This letter will address the manner in which the alluvial material adjacent to the landfill is handled during Phase 1A of operations and the resulting impact on the monitoring of this unit. Also included are proposed locations of 'western boundary' alluvial monitoring. This report, in conjunction with the letter to you, dated August 23, 2001 should fully address the four issues we discussed in Roswell on July 19, 2001.

2. Western boundary monitoring wells - Gandy Marley, Inc. is committed to installing a fence of four monitoring wells in the alluvial sediments west of the operating area. This is a direct response to comments expressed at the recent public meetings. The purpose of this fence of monitoring wells is to ensure that the Triassic Park Disposal Facility is protective of any water in the alluvium and will have no impact on the existing wells currently producing from these sediments five miles west of the facility.

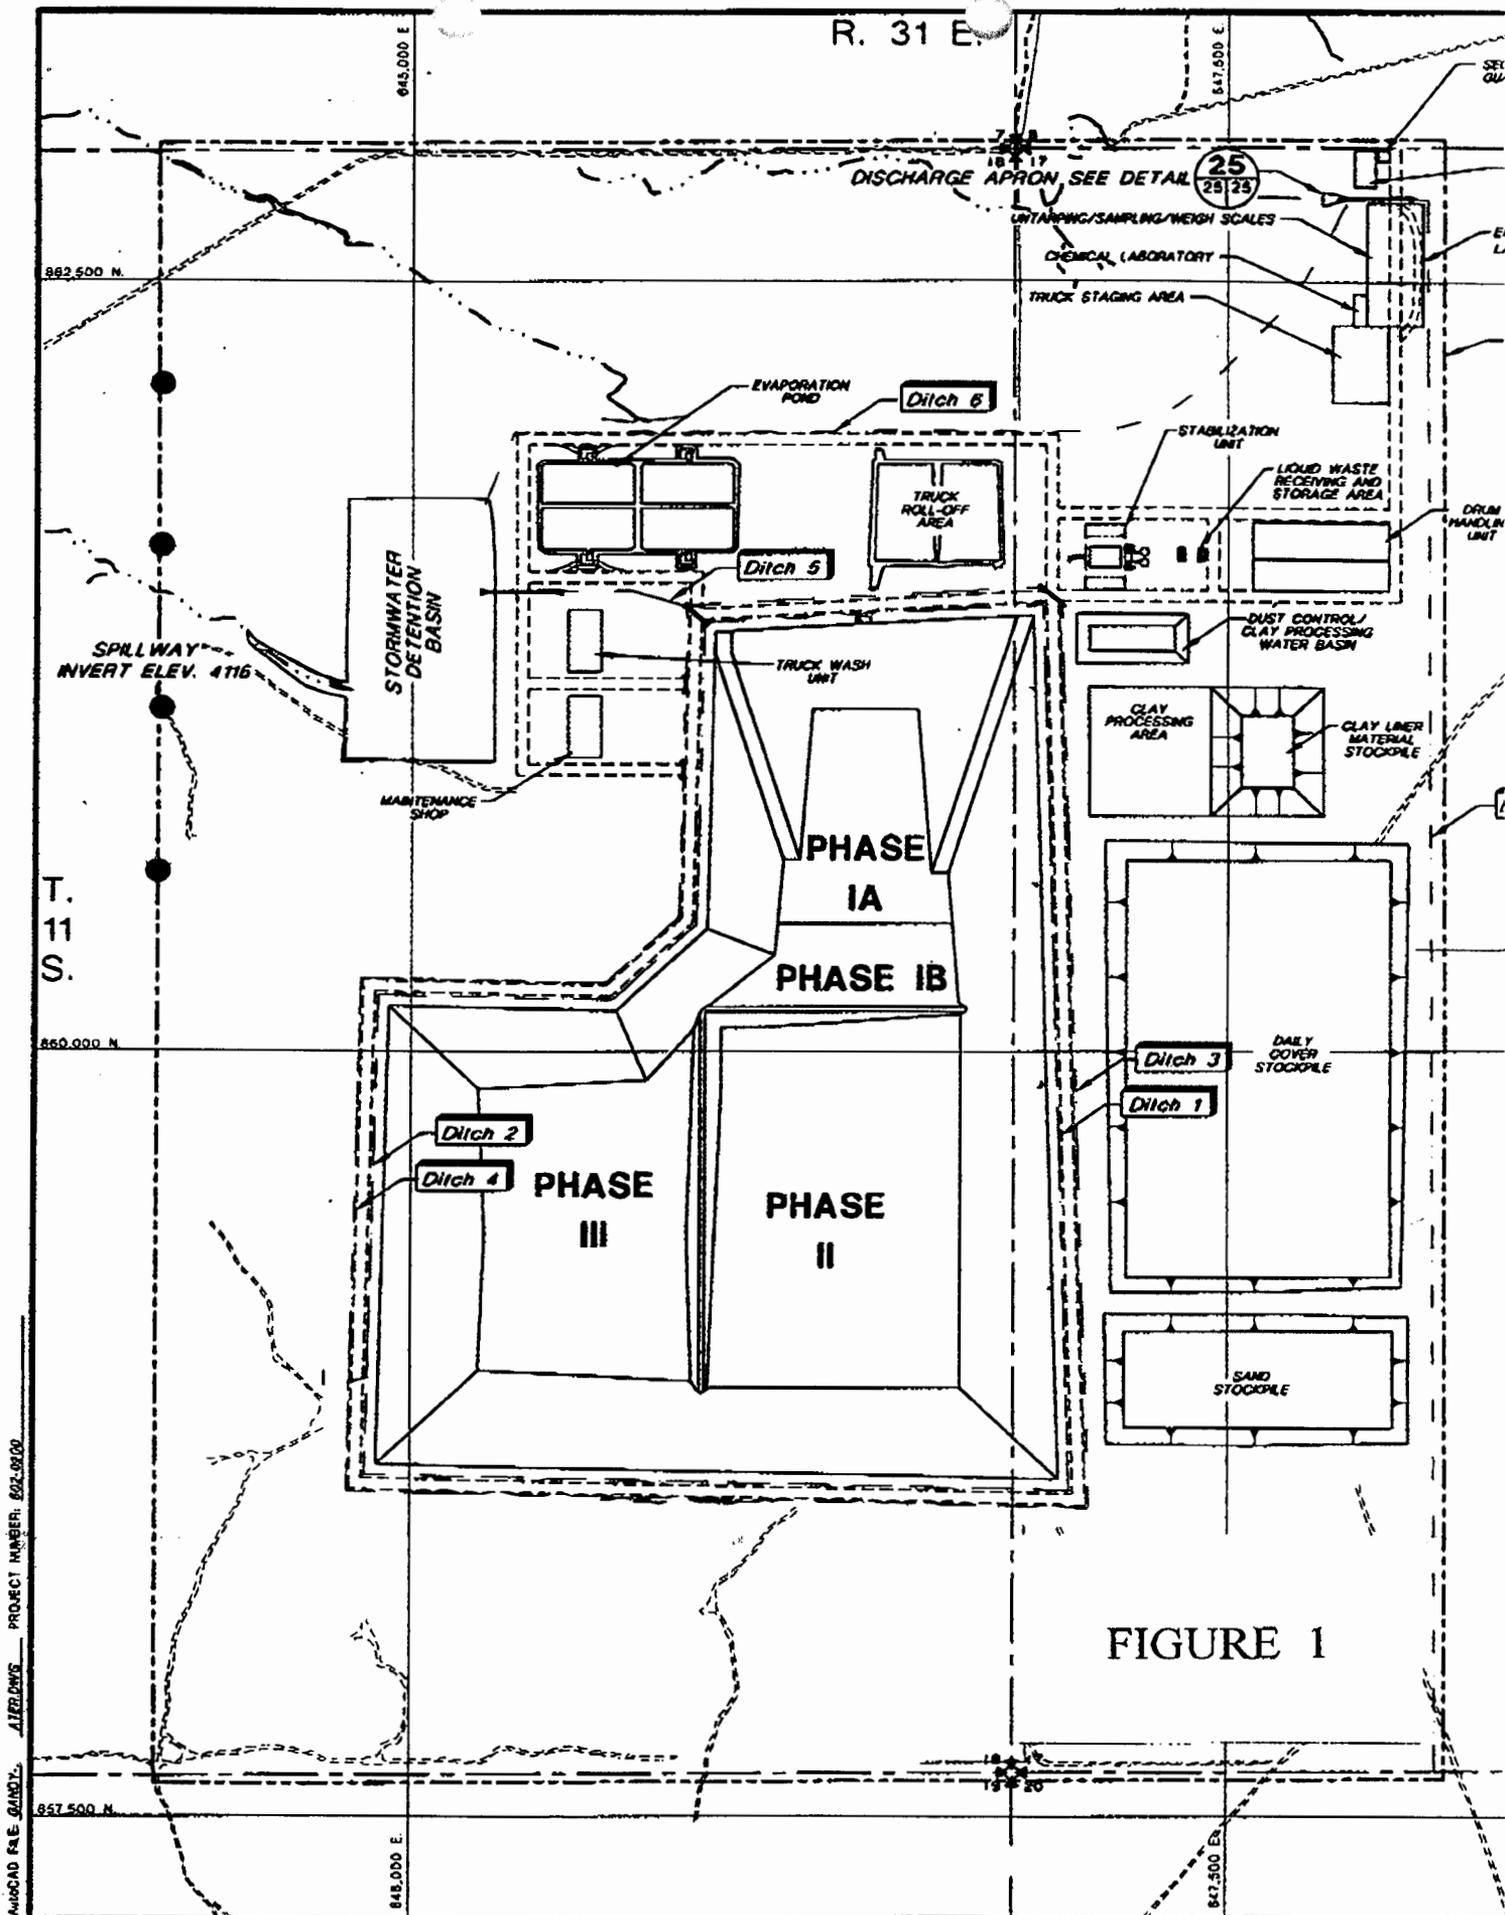
- **Option 1** - As we have discussed, Figure 1 shows a fence of monitoring wells along the western property boundary. These wells are positioned at 500-foot intervals along the boundary. They are west of and topographically below all Phase 1A operational areas, including the Stormwater Detention Basin.

Although this is the location we had discussed in the past, it is not our preferred location for the following reasons.

- 1) As described above, the alluvial sediments will be stripped away from the sides of the landfill and completely exposed during this phase. There will be no waste activities in the upper portion of the landfill and alluvial sediments will have no contact with hazardous materials.

- 2) We have been stating in public meetings that we are installing monitor wells adjacent (within hundreds of feet) to operational facilities so that any excursion could be recognized early and dealt with before it reaches the site boundary.

- 3) This proposed fence of monitoring wells is topographically below the Stormwater Detention Basin. This feature is designed to collect uncontaminated water from storm events and direct this water away from the operational area. In this case, it would direct this water into the area of shallow monitoring wells. It is very likely that fluid may be seen in these dry wells after the water from a storm event is diverted into these alluvial sediments. This fluid would have nothing to do with the landfill operations, but would certainly cause an interruption in activities.

FIGURE 2

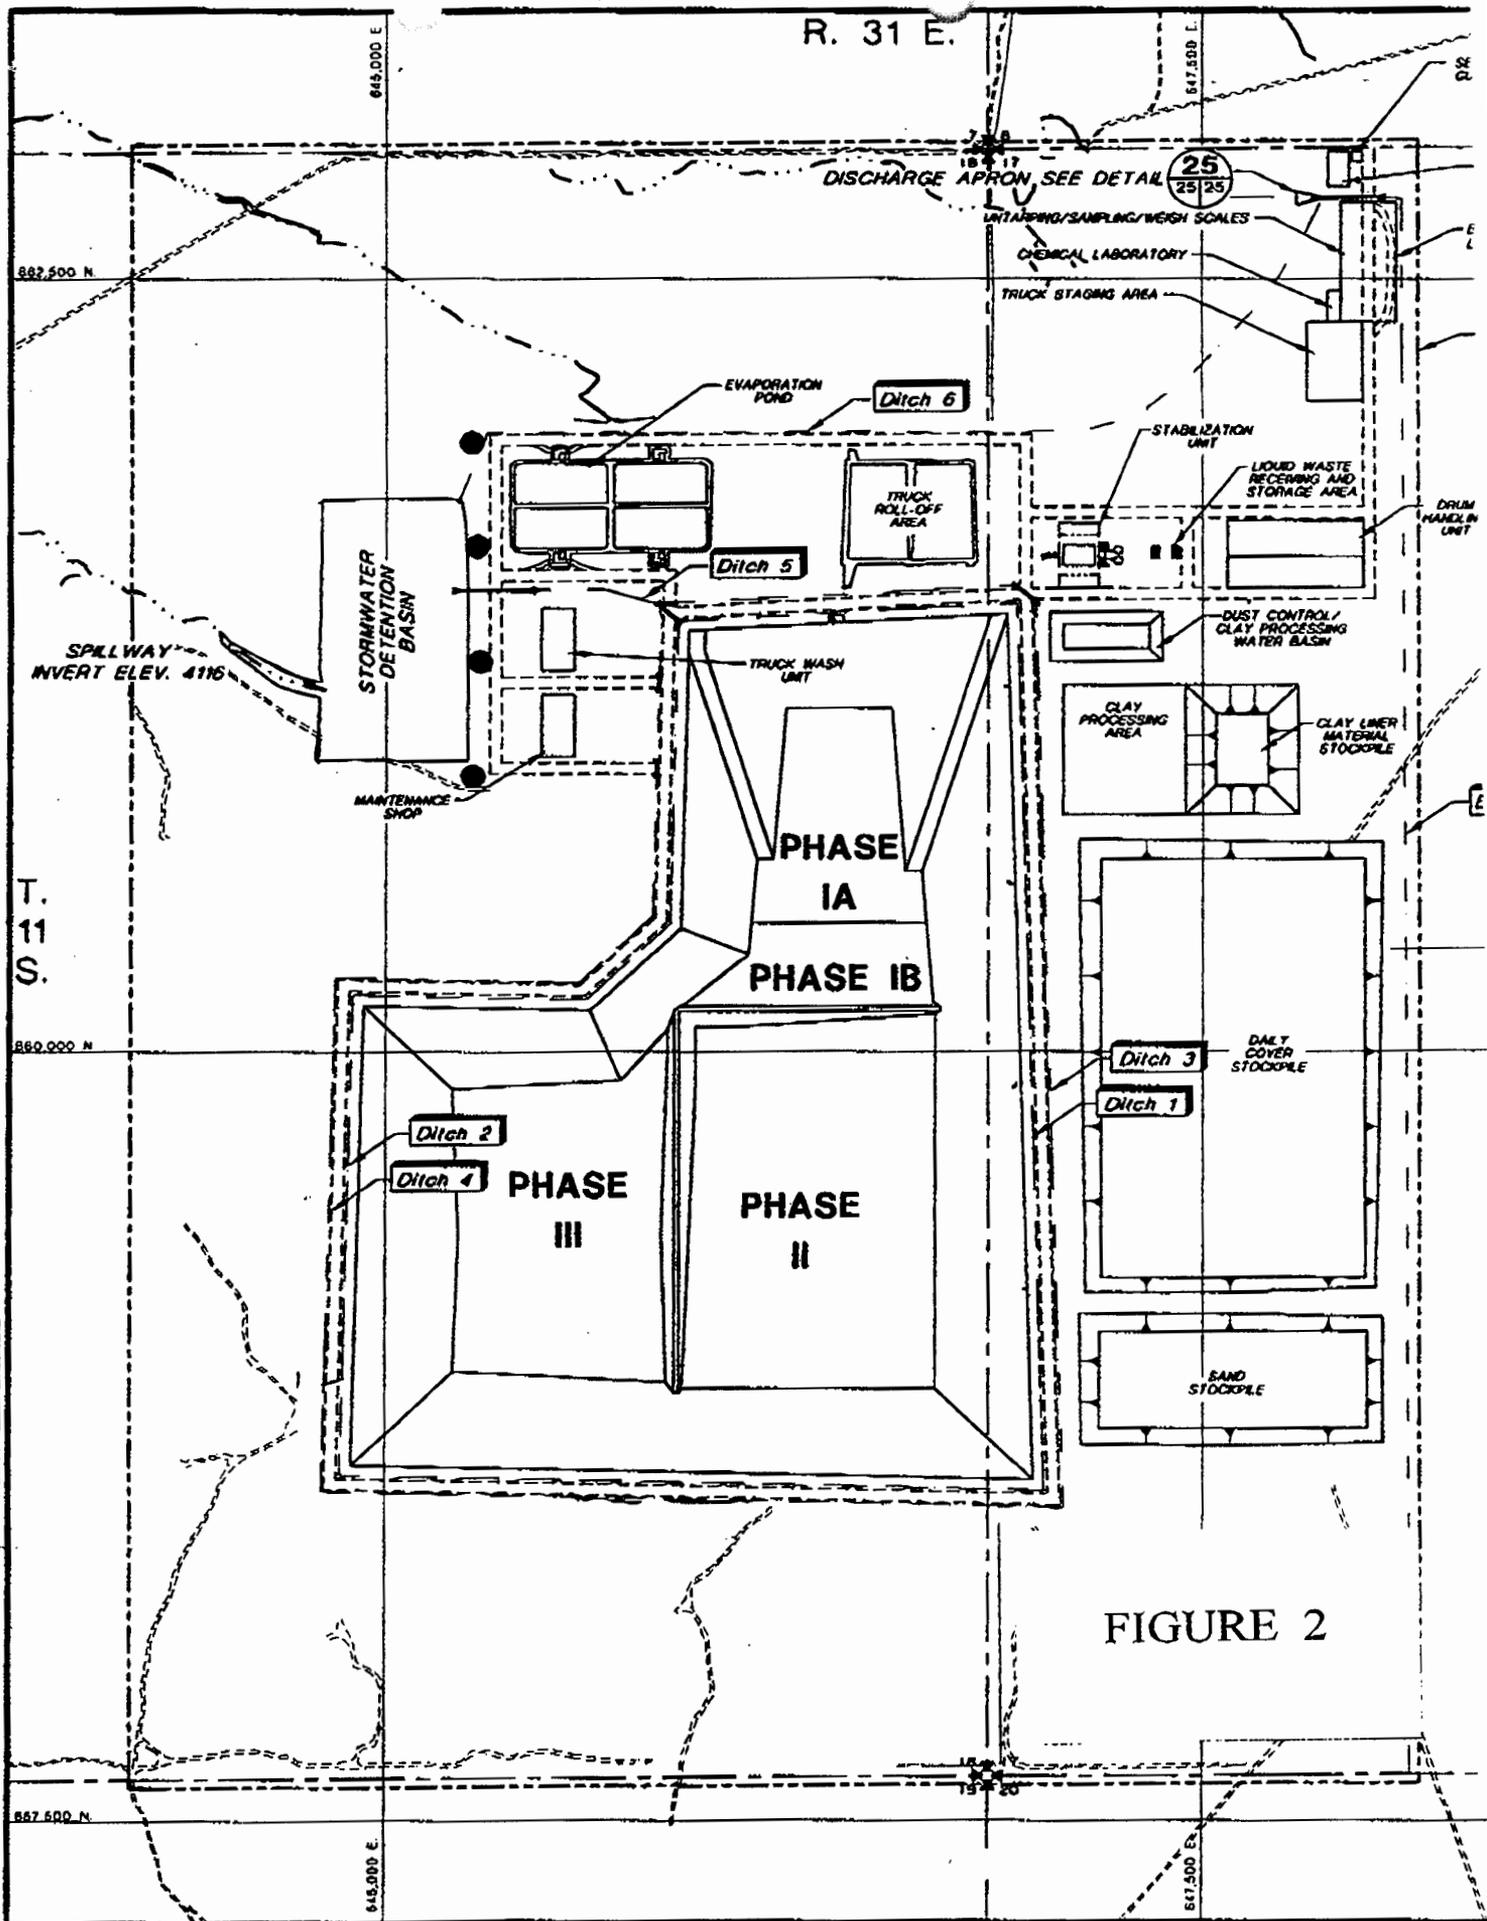
- **Option 2** - Our preferred location is shown in Figure 2. Instead of locating the fence of wells along the western property boundary, they would be located along the western boundary of the operations area. These wells would be spaced at approximately 330-foot intervals along this fence. This accomplishes the original purpose for a fence of monitoring wells, but in a more efficient manner.

Our rationale for this includes:

- 1) These wells would be within hundreds of feet of the western operational units - Evaporation Ponds, Truck Wash Unit and Maintenance Shop. In the unlikely event of an excursion, these locations allow Gandy Marley a quicker response time.
- 2) For the reasons mentioned above, there is no need to have a monitor well adjacent to the Phase 1A landfill. No monitoring well would give the amount of information that will already be available from stripping away and exposing an entire unit.
- 3) These monitoring wells would be placed to monitor operational facilities, not the Stormwater Detention Basin and avoid unnecessary complications.
